Interactive comment on "Balancing energy and environmental concerns: the case of the Kayraktepe dam, Turkey" by Ö. Sever et al.

We would like to thank for the valuable comments of the reviewer #2. We have reviewed referee' suggestions, and the necessary changes and explanations will be made in the revised article. An item-by-item summary of our responses to the review comments is provided in this sheet

Fig. 1. Figure 1b

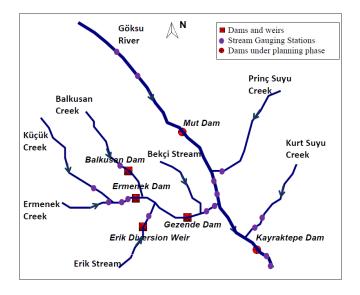
11775-14 In the same vein as the comment above, the Mut Dam is introduced to the discussion with no preparation, as though the reader is already informed about its background and role in the system. This makes it very difficult to interpret the flood control functions of the dams. 11776-7 Again the Mut Dam is introduced to play a major role in the flood routing of the Kayraktepe Dam reducing the flood volume dramatically, but with no indication of how this was achieved. Because of this the description of the performance of all the dams in this system is not systematic and is difficult to interpret.

The figure 1 re-drawn to clear out the confusion.
